INTERNATIONAL CODE COUNCIL

2009/2010 CODE DEVELOPMENT CYCLE

2009/2010 FINAL ACTION AGENDA FOR THE PROPOSED CHANGES TO THE 2009 EDITIONS OF THE

INTERNATIONAL BUILDING CODE®

Figure 1. Growth of Home Stair-related Injuries in USA in Recent Years.

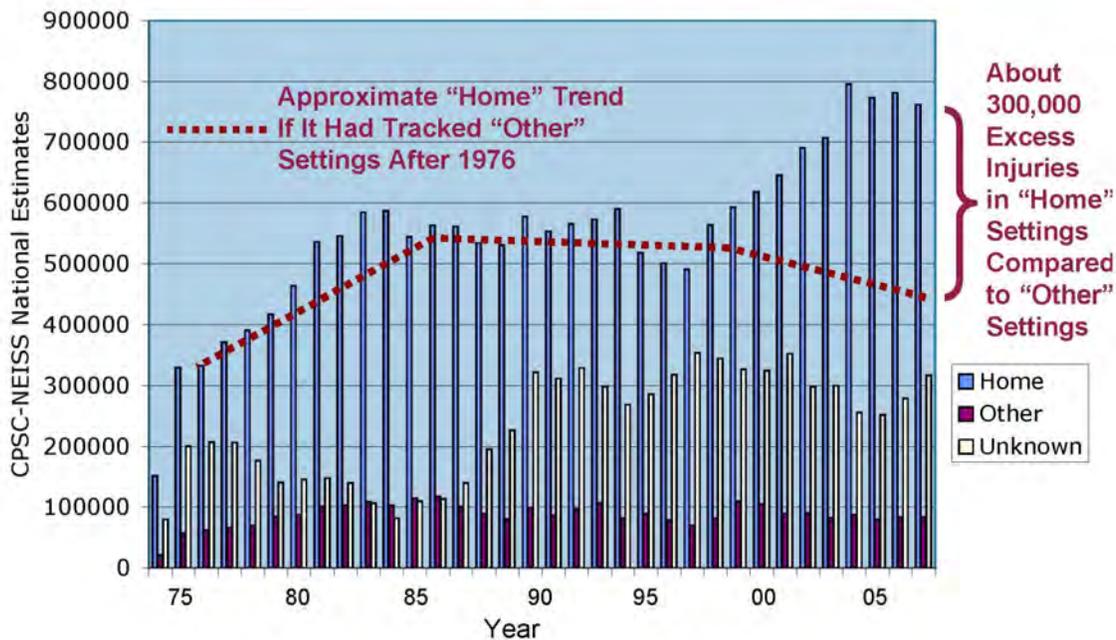
My special concern here is the apparent widespread failure to build and inspect stairs with regard to uniformity of nosing projection, especially at the top of stair flights. For this reason alone, it is important for this section—with a few topics in one paragraph—to be divided into smaller pieces dealing with a smaller set of issues. It appears that the nosing projection uniformity issue— particularly omitting the nosing projection on the landing nosing—might be mostly responsible for the rapid growth of what I refer to as “Excess Injuries” in Figure 1. Over the several years where these “Excess Injuries” have been seen in the CPSC-NEISS national estimates, there have been a total of about 2 million such “Excess Injuries” which have an associated annual societal cost in the USA of about \$200 billion (yes, that is billion with a “b”) with the medical care component of these “Excess Injuries” accounting for about \$20 billion. (The substantial basis for these cost-of-injury estimates comes from the work of Lawrence, et al., 1999.)

The resulting non-uniformities in tread depths, with a larger top tread followed by smaller treads in the flight make the stair flight orders of magnitude more dangerous for descent-direction users. This pervasive systemic defect has also become so concerning to leading stairway safety professionals such as myself that a special website page has been created simply to deal with this issue. See <http://web.me.com/bldguse/Site/Stairways.html> for information on this including the graph provided below as Figure 1 showing a large increase in the number of home stair-related injuries identified in the CPSC NEISS national estimates for the USA in the last several years. Excerpts of text from the Stairways website page are also quoted below as are excerpts from an American Society of Safety Engineers 2008 Professional Development Conference paper by Pauls and Harbuck. The full ASSE conference paper is freely accessible as a PDF download from the Downloads area of my website, <http://web.me.com/bldguse/Site/Downloads.html>. Generally, it is suspected that with recent greater use of manufactured stair flights, the incidence of systemic, top-of-flight non-uniformities has grown with resulting significant increases in home stair-related injuries.

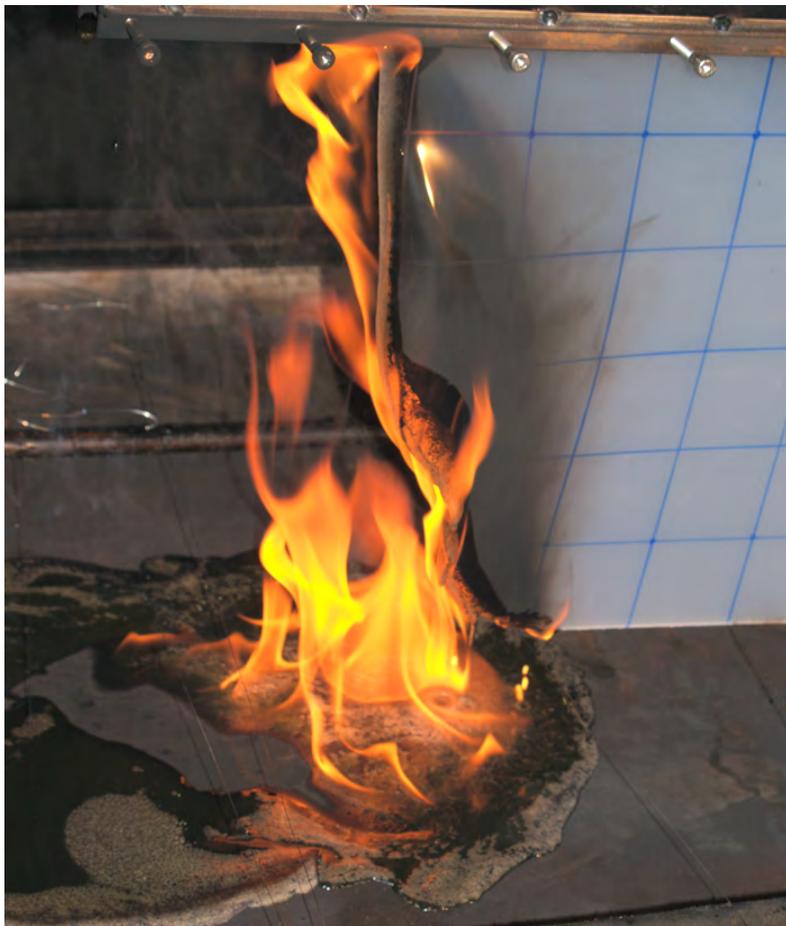
It is possible to make properly flame retarded polypropylene and use it for siding because flame retarded polypropylene can easily be compounded so that it does not melt/drip and pass the requirements of a flame spread index of 200 in the ASTM E 84 test. In fact, the original proposal includes an ASTM E 84 test with an FR polypropylene material that gave a flame spread index of 50. Such a material should be permitted for use but not the unsafe material normally offered for sale.

The missing Figure from the proposal (that could also be found with proposal RB148) is found below. It shows what happens when normal non flame retarded polypropylene (the material that is used in siding) burns: it forms a pool fire. The photograph is not polypropylene siding but its component material.

FIGURE R302.2.1(1)
Example assemblies that can be used to make up a one-hour rated system for separation between occupancies

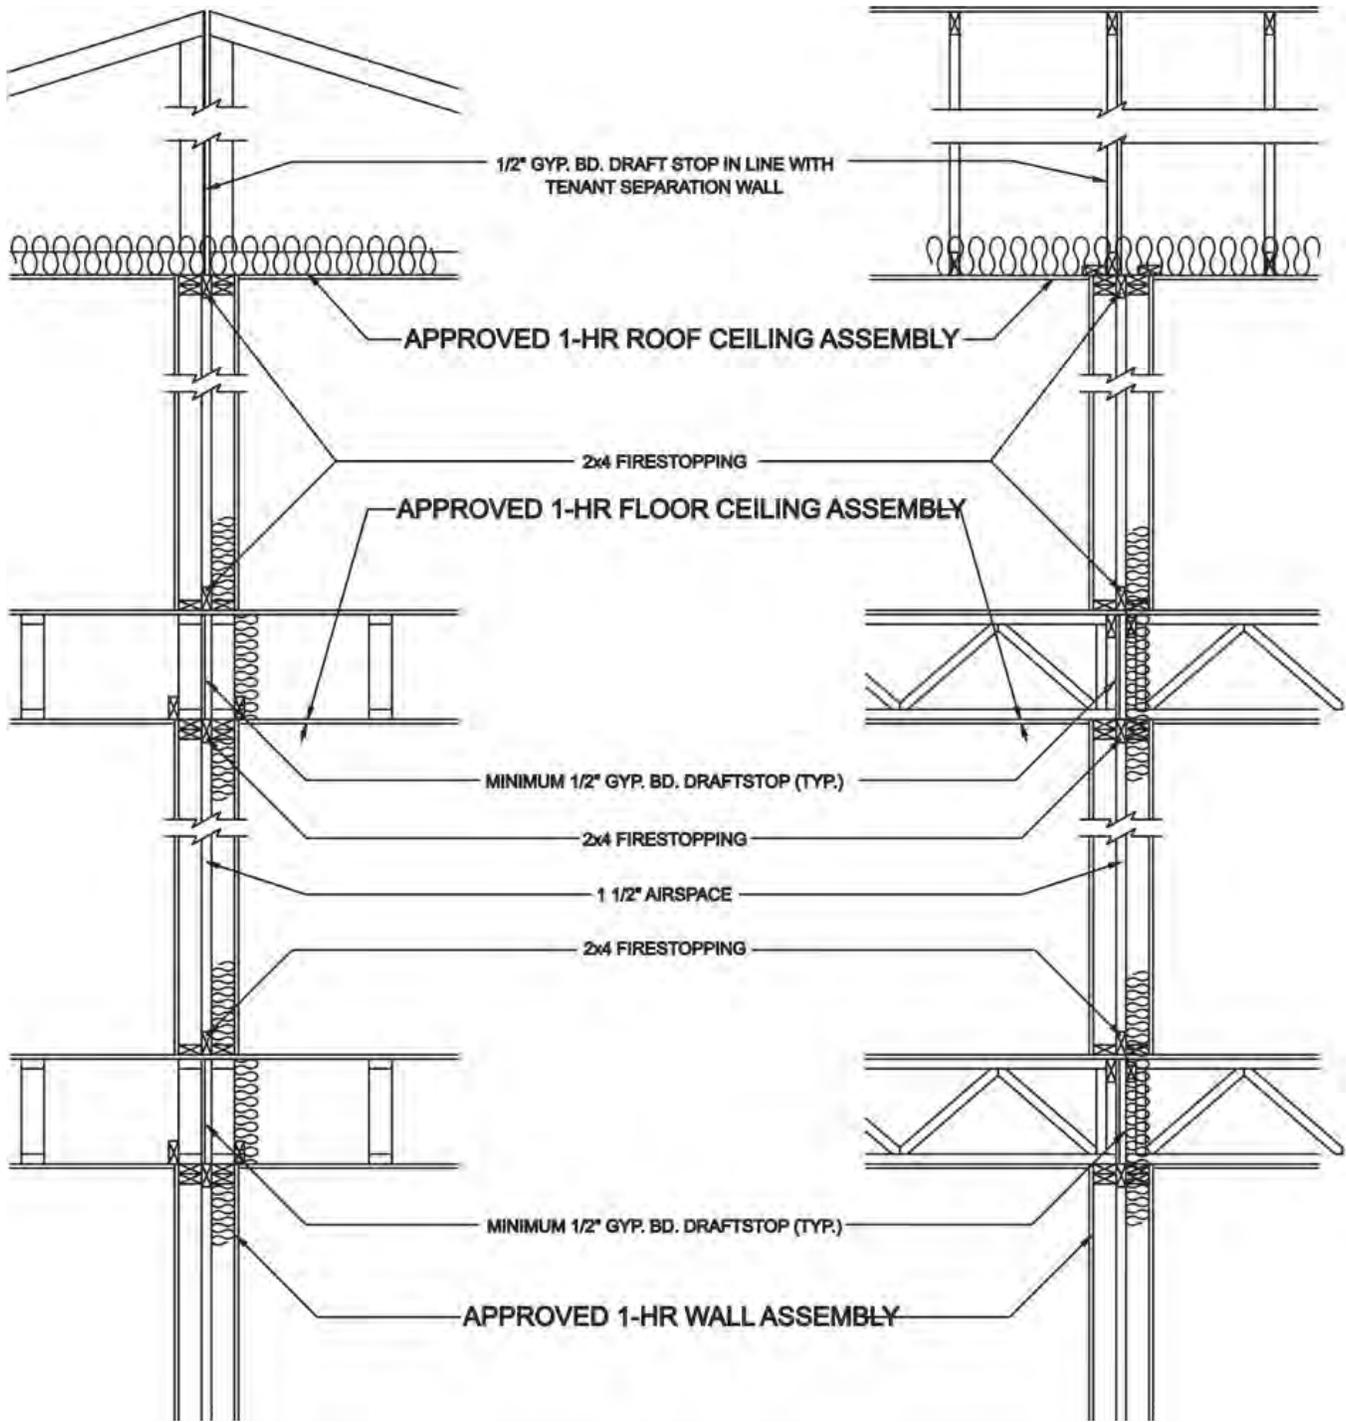
2. Add new figures as follows:

FIGURE R602.10.6.2(3)
BRACED WALL PANEL CONNECTION OPTION TO PERPENDICULAR RAFTERS OR ROOF TRUSSES

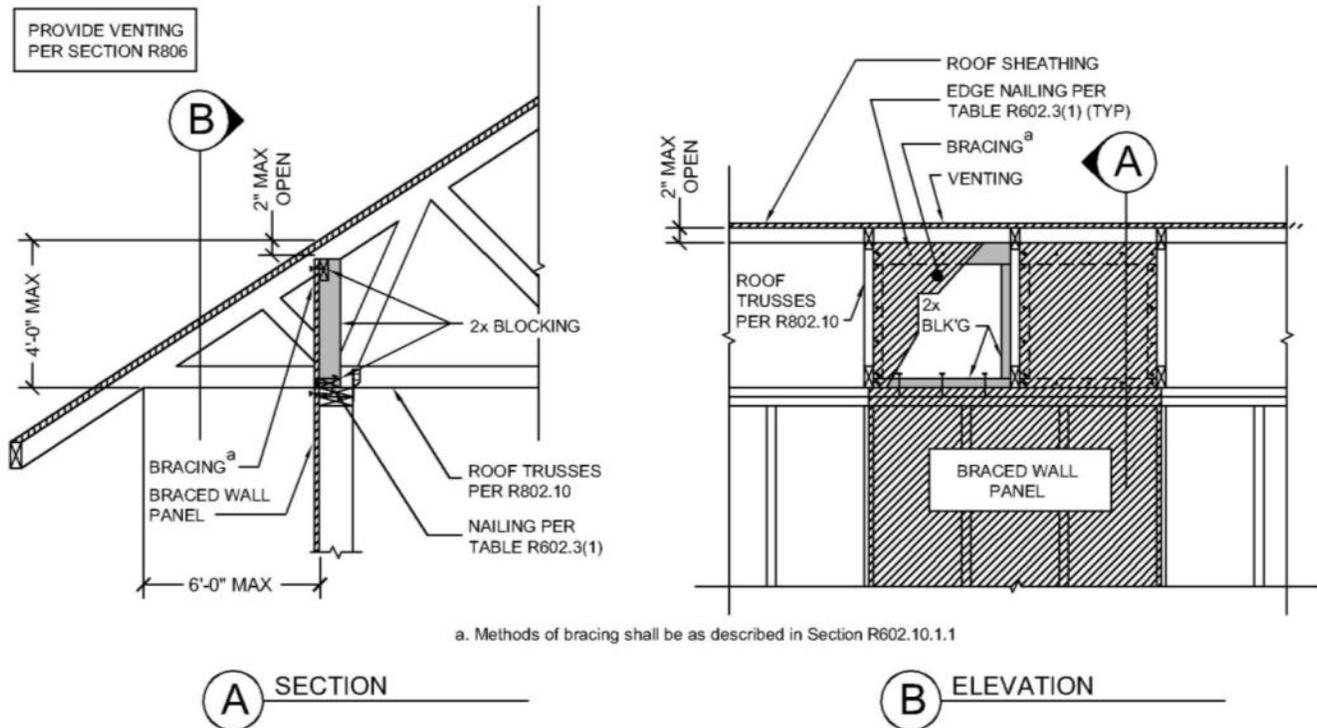
3. Replace Figure R602.10.6.2(3) with the following:

**FIGURE R802.5.1
BRACED RAFTER CONNECTION**

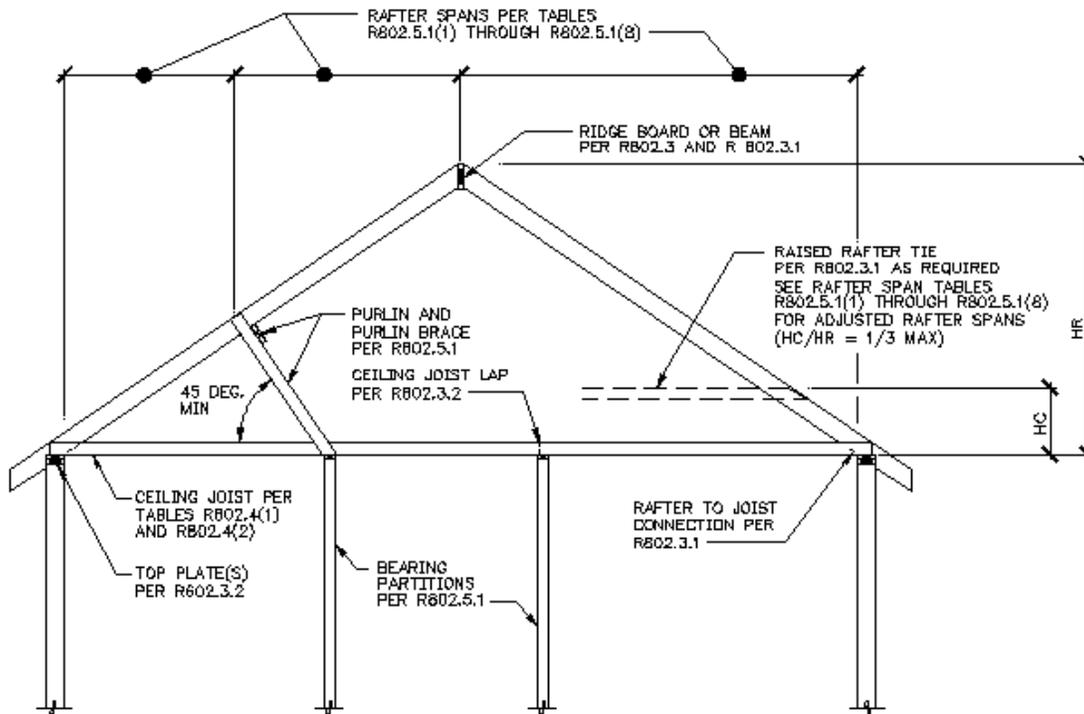
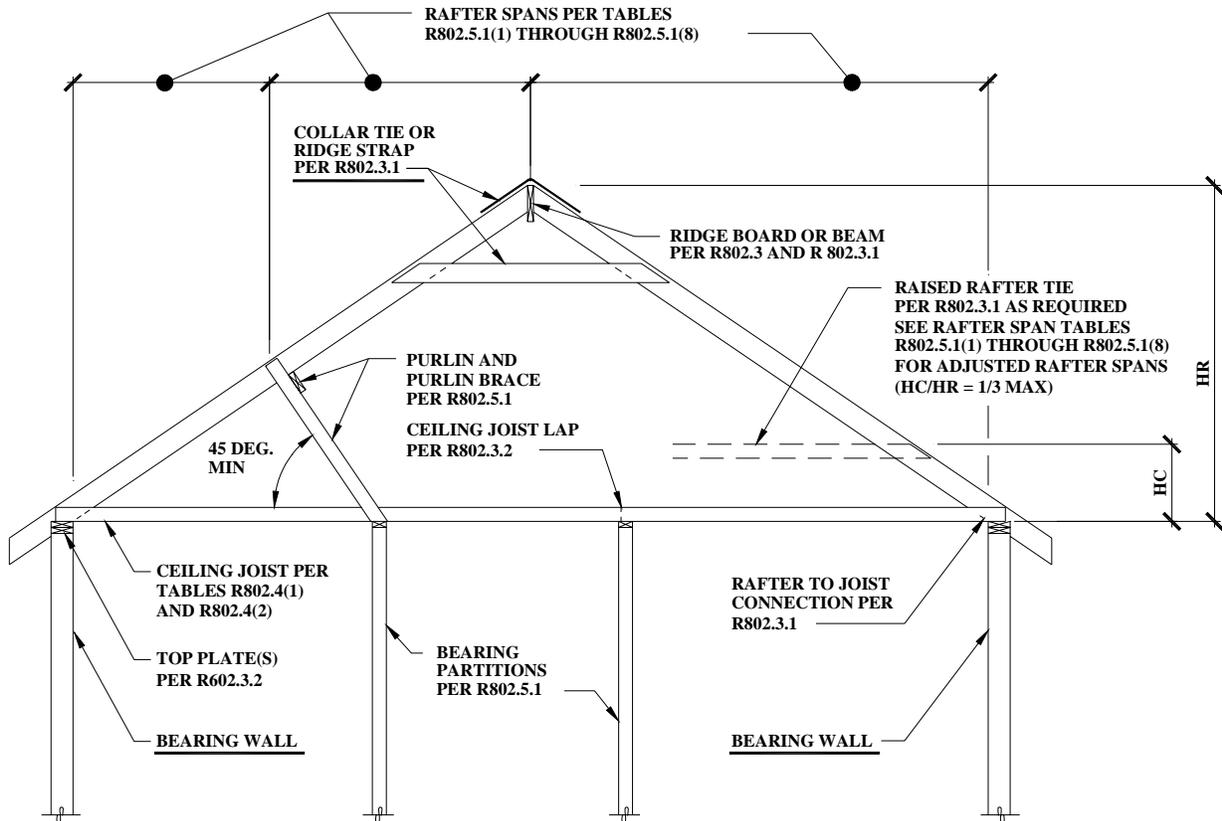
Delete existing Figure R802.5.1 and replace as follows:

Modify the proposal as:

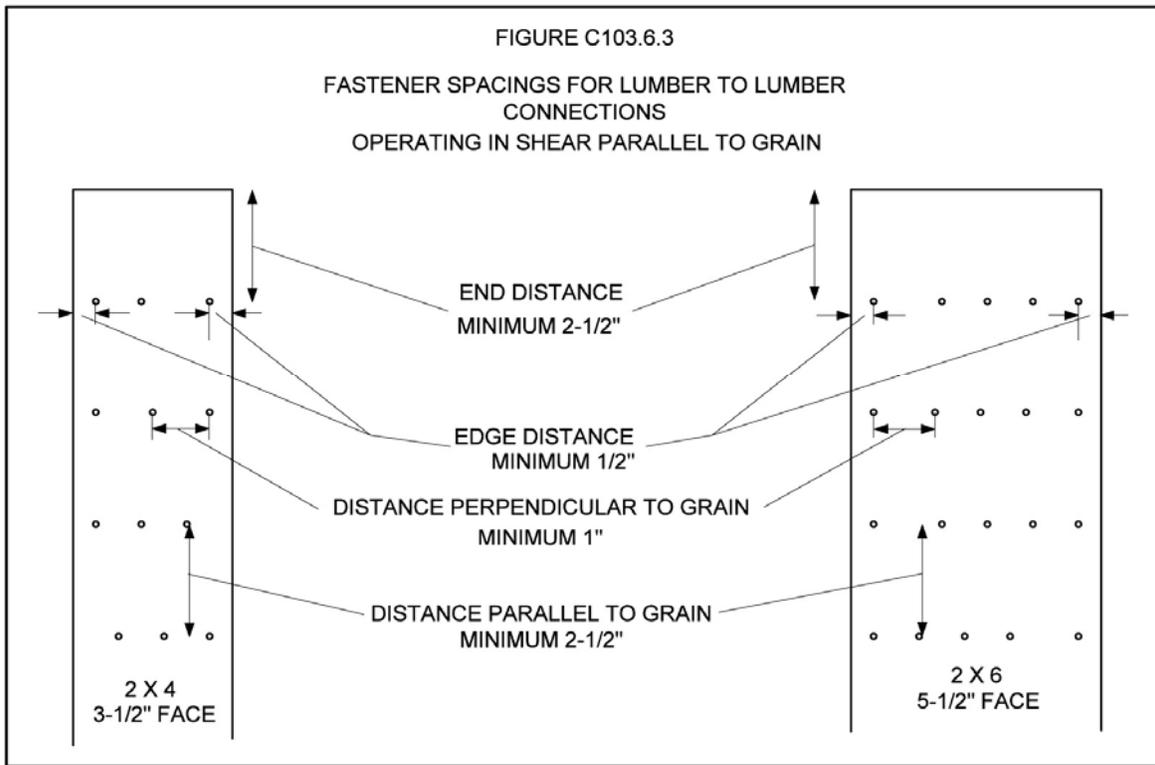
Figure C103.6.3 revise the phrase in the third note from the top "Distance across grain minimum 1 inch" to "Distance perpendicular to grain minimum 1 inch"
